Appeal to An Comisiún Pleanála

Re: Appeal against Grant of Permission for Retention

Planning Reference: D26B/0409/WEB

Development: Retention of detached garden studio and associated works

Image 1: Estimates that the actual height of the structure may exceed 4.0 metres above ground level and may be approximately 4.4 metres.

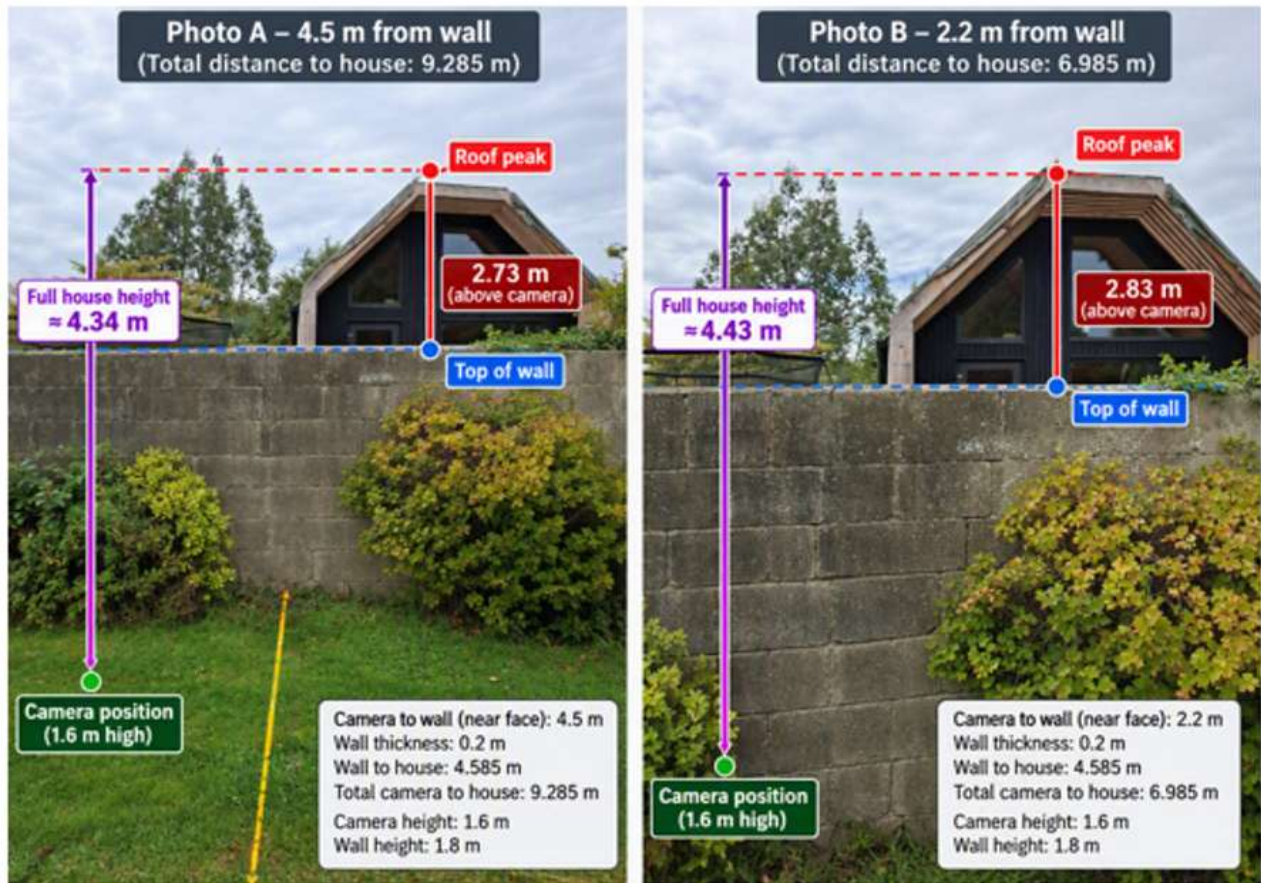
- The submitted drawings show an overall height of approximately 4.0m.
- The drawings appear to measure height from the internal floor level rather than existing external ground level.
- The floor level itself appears to be approximately 0.5m above surrounding garden level.
- This could result in an overall structure height materially exceeding that described in the assessment.

- **Photo A** is taken from a measured position approximately 4.5 m from the boundary wall, with the camera approximately 1.6 m above ground level. The boundary wall has a measured height of 1.8 m.
- **Photo B** is an independent photograph taken from a second measured position approximately 2.2 m from the same boundary wall, with the camera approximately 1.6 m above ground level and the same unzoomed camera setting used.
- **Photos A and B** were analysed independently and calculated with AI assistance.
- **Photo A** produces an estimated height of approximately 4.34 m, while **Photo B** produces an estimated height of 4.43 m. The combined estimate is approximately **4.4 m**.

While photographic measurements do not constitute a professional measured survey, they nevertheless constitute new evidence raising a credible and material question concerning the actual height of the development for which retention permission has been granted.

Image 2: Distance between main dwelling and rear boundary at No. 30 Whitebarn Road
(Measured on Google Maps)

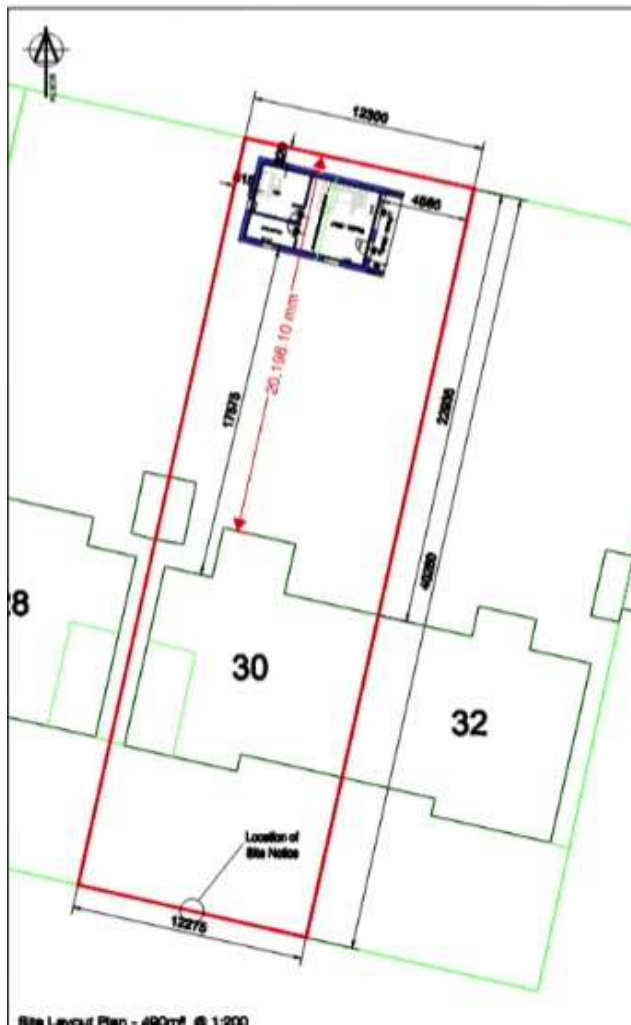
Submitted Site Layout Plan: 20.20m

Aerial image: 18.11m

Difference: 2.1m

Submitted plan distance is approximately 11% greater than the aerial image distance. Aerial measurements are comparative and are not presented as a substitute for a professional site survey.

- The plans are not accurate as the site layouts to Nos. 30 and 32 Whitebarn Road are incorrect.
- The submitted Site Layout Plan creates the misleading visual impression that the garden studio is much further away from the established residential development and neighbouring properties than appears to be the case.

Image 5: View from my bedroom while sitting on the bed

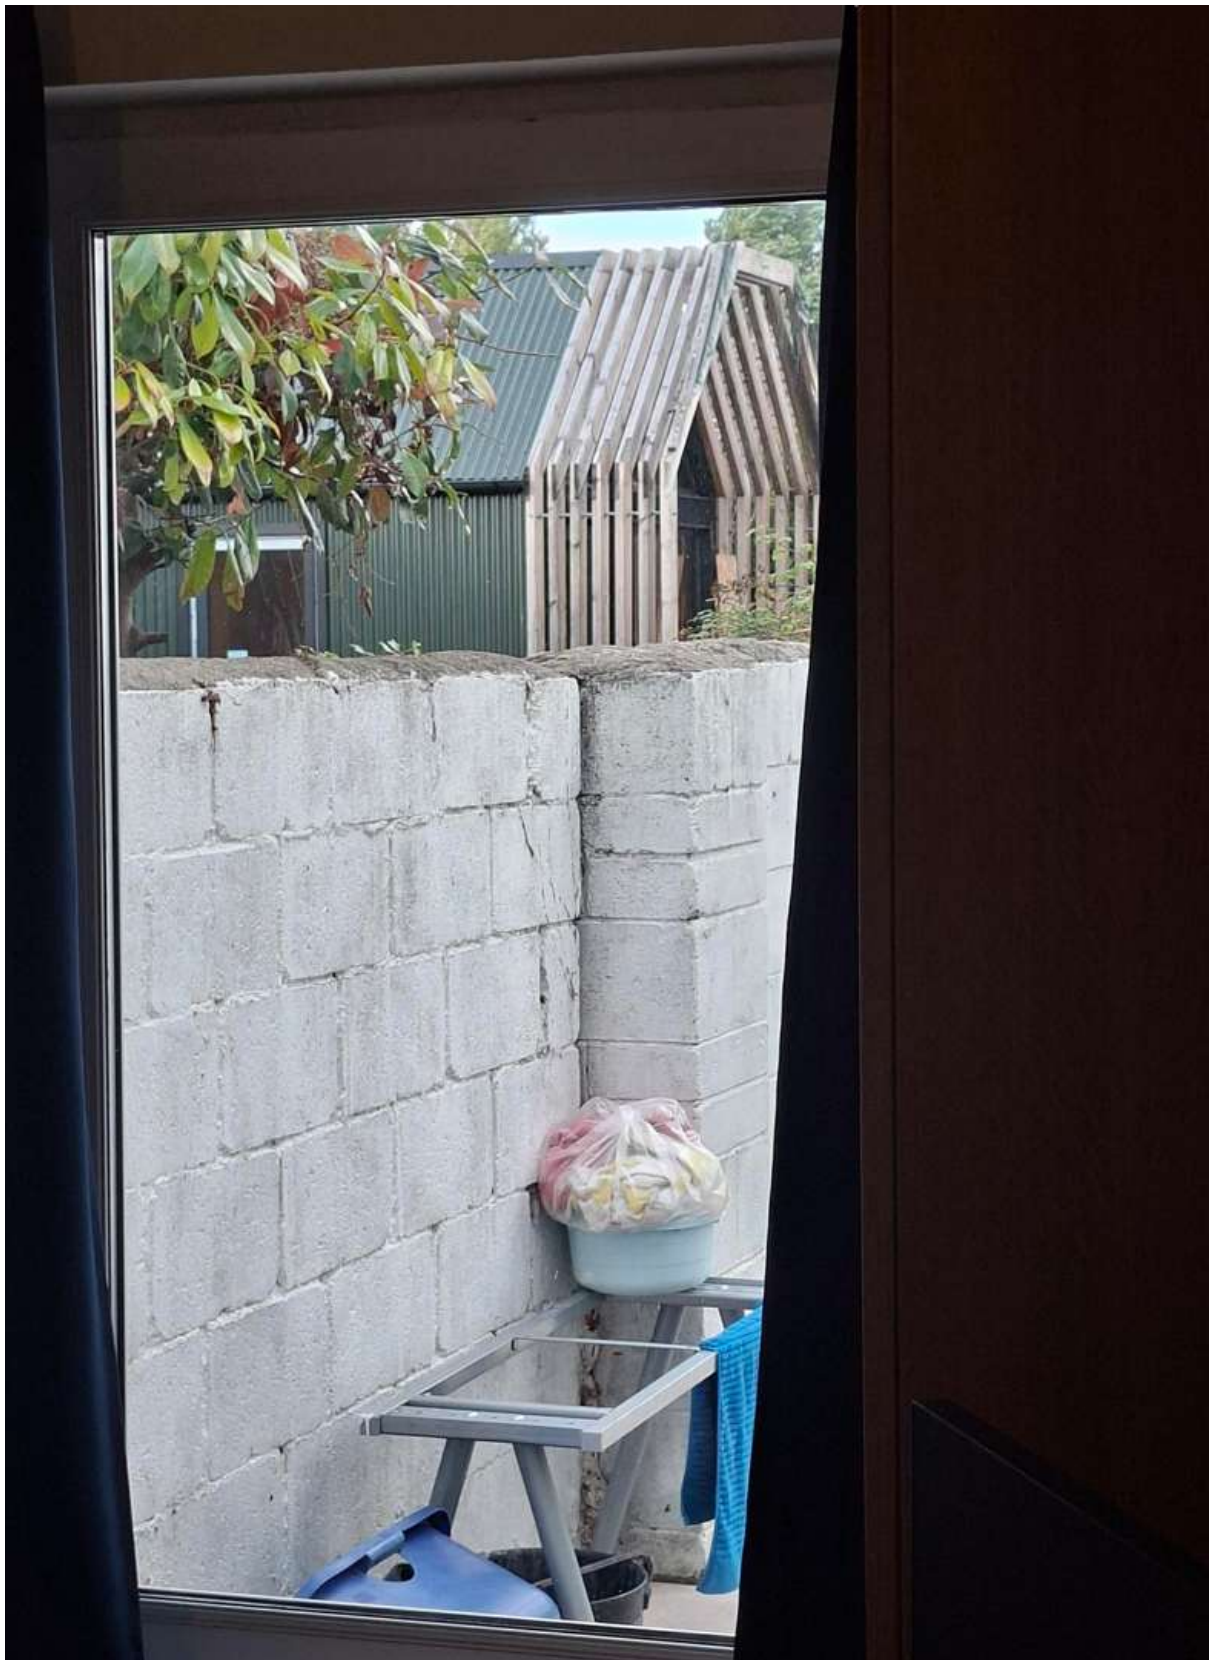
Images 4 – 6 show the views from the private rear rooms of my dwelling, demonstrating the direct line of sight towards the elevated porch and entrance of the garden studio.

The direct visual relationship between the garden studio and my property, as seen in Images 4 – 6, arises from a number of factors:

- the design and orientation of the structure itself, in particular the location of the elevated entrance porch and extensive glazing on the elevation facing my property (rather than the rear of the site at 30 Whitebarn Road),
- the calculated height of the structure (Image 1),
- the vertical relationship between the properties,
- the respective levels of the garden studio and my dwelling (the elevated position of the studio and the approximately 0.2m raised floor level of my dwelling).

The sightline from the studio towards the windows and private rooms at the rear of my dwelling is not merely a theoretical concern. People entering the garden studio via the elevated porch are clearly visible from the private rear rooms of my dwelling. Equally, people standing near the windows inside the studio are visible from our property.
